# Memorandum to the City of Markham Committee of Adjustment

**File:** A/140/20  
**Address:** 8 Dove Lane – Markham, ON (Thornhill)  
**Applicant:** Yousef Kimiagar  
**Agent:** JKO Planning Services Inc.  
**Hearing Date:** February 17, 2021

The applicant is requesting relief from the following “Third Density Single Family Residential (R3)” zone requirements under By-law 2237, as amended, as they relate to a proposed new single detached dwelling. The variances requested are to permit:

Site Plan		Scale:	Date:	Yousef Kimiagar 8 Dove Lane Markham
Sheet:	<b>A - 2</b>	1/12 in = 1 ft	February 7, 2021

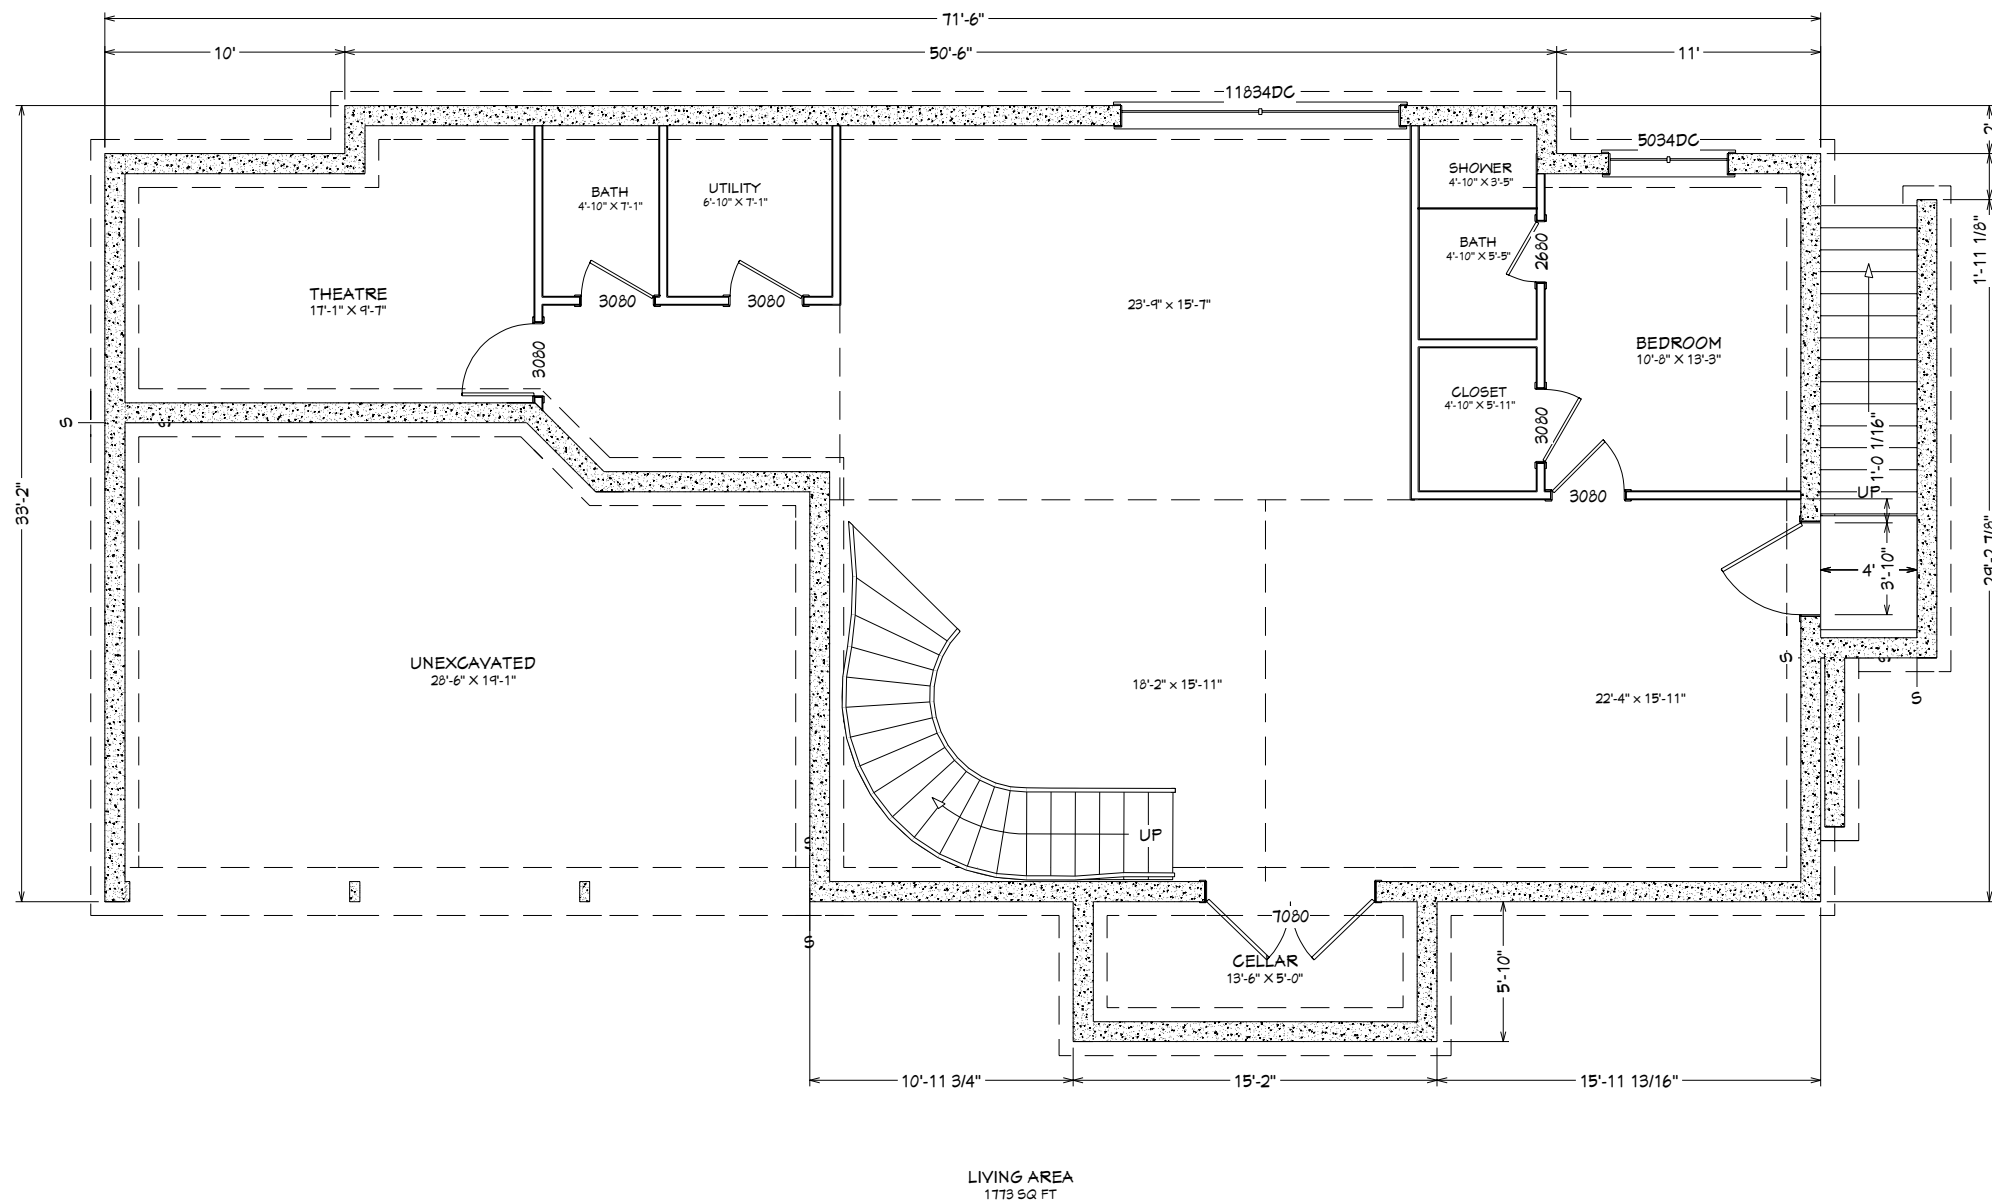
The applicant is requesting relief to permit a minimum front yard setback of 17.85 ft (5.43 m), whereas the By-law requires a minimum front yard setback of 27.0 ft (8.23 m). This is a reduction of 9.15 ft (2.79 m).

The variance is attributable to the below grade cold cellar which is setback approximately 17.85 ft (5.43 m) from the front lot line. The applicant submitted plans which propose a

main front wall of the building which provides a front yard setback of approximately 23.65 ft (7.21 m) as shown in the attached plans (Appendix “B”).

Staff note that the proposed development would have a setback above grade that is generally consistent with other building setbacks along Dove Lane, and have no objections.

The applicant is requesting a minimum main building setback of 5.43 m (17.81 ft), whereas the By-law requires a minimum main building setback of 8.0 m (26.25 ft) from the street line. Staff are of the opinion that the proposed development would have a main building setback that is generally consistent with other building setbacks along Dove Lane.

Similar to the applicant’s request to reduce the front yard setback, staff are of the opinion that the request is in part attributable to a below grade cold cellar as discussed above. Staff similarly do not object to the variance.

# DOVE LANE TREE PRESERVATION PLAN

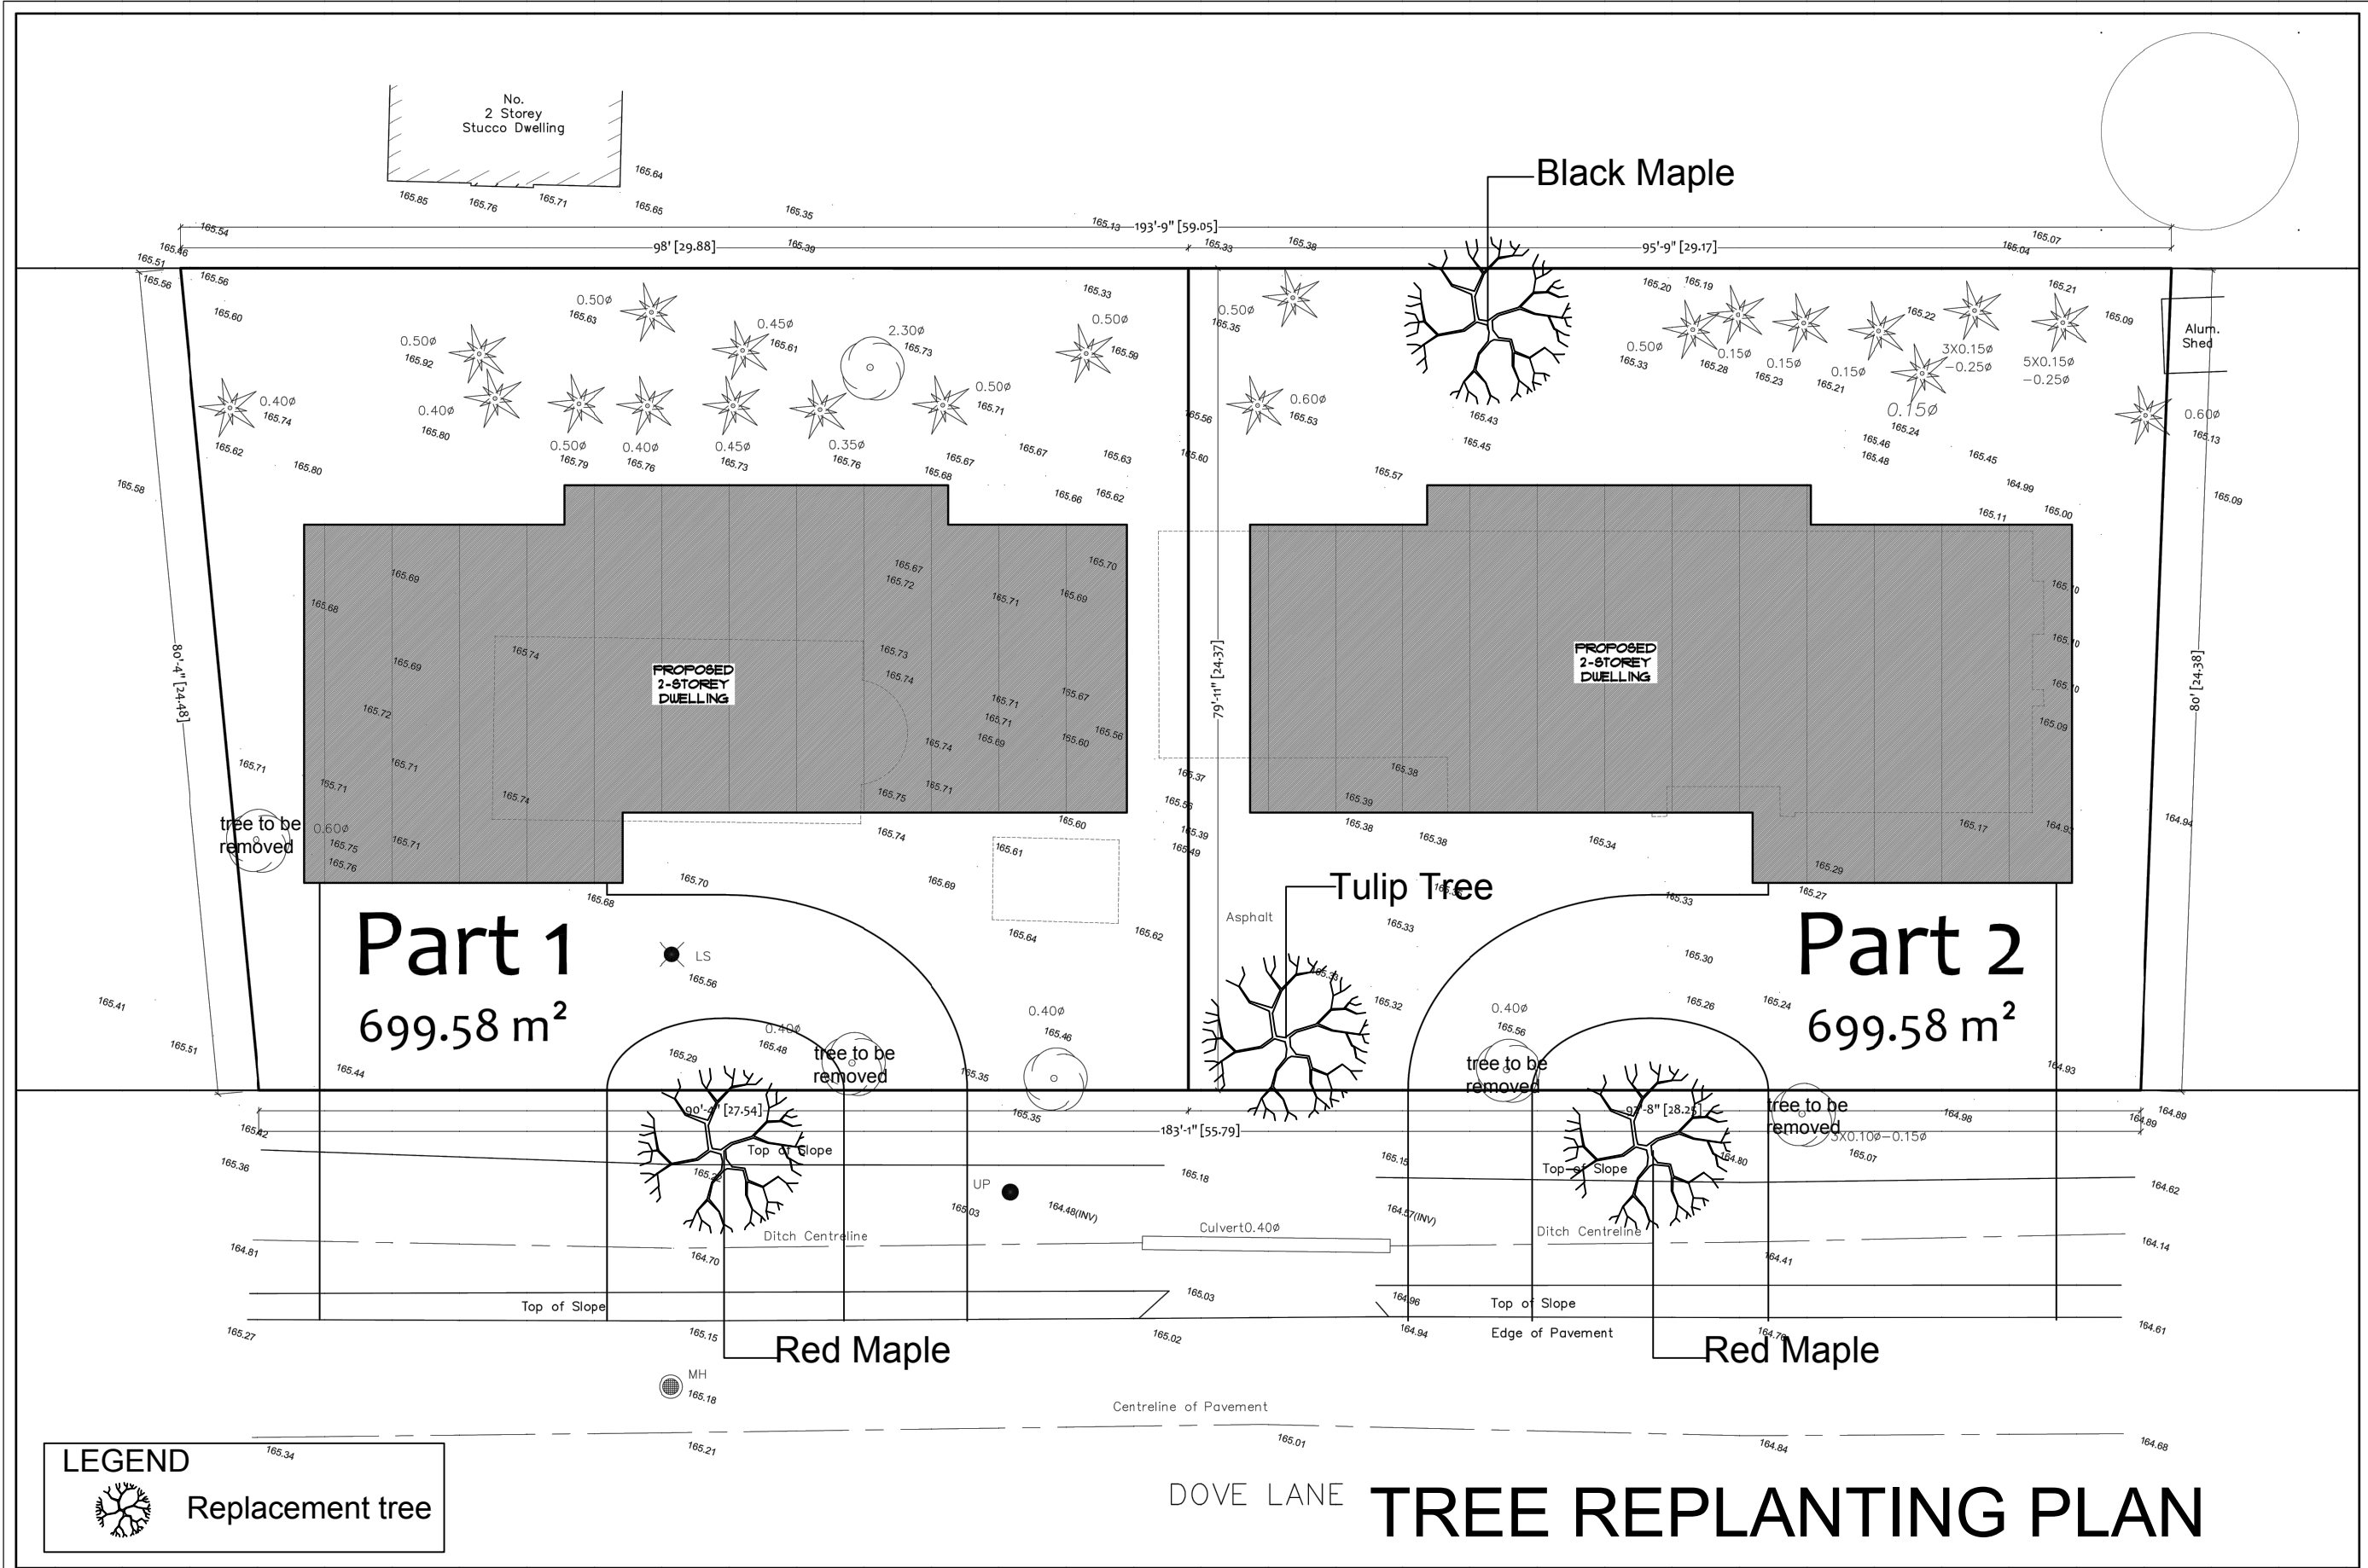
The applicant submitted Tree Preservation and Planting Plans (Appendix “C”), proposing to remove two trees, and protect seventeen trees which are located along the rear lot line. The applicant is also proposing to protect one existing tree located in the front yard, and to plant one additional tree in the front yard.

Urban Forestry staff has reviewed the application, and have requested that the tree assessment and preservation plan be subject to further review. Accordingly, staff recommend that any approval of the variance application includes related tree protection and compensation conditions attached in Appendix “A”.

3. Submission of a Tree Assessment and Preservation Plan, prepared by a qualified arborist in accordance with the City's Streetscape Manual (2009), as amended, to be reviewed and approved by the City, and that the Secretary-Treasurer receive written confirmation from Tree Preservation Technician that this condition has been fulfilled to his/her satisfaction, and that any detailed Siting, Lot Grading and Servicing Plan required as a condition of approval reflects the Tree Assessment and Preservation Plan.

4. That prior to the commencement of construction or demolition, tree protection be erected and maintained around all trees on site, including street trees, in accordance with the City's Streetscape Manual (2009) as amended, and inspected by City Staff to the satisfaction of the Tree Preservation Technician.

5. That tree replacements be provided and/or tree replacement fees be paid to the City if required in accordance with the Tree Assessment and Preservation Plan, and that the Secretary-Treasurer receive written confirmation that this condition has been fulfilled to the satisfaction of the Tree Preservation Technician.
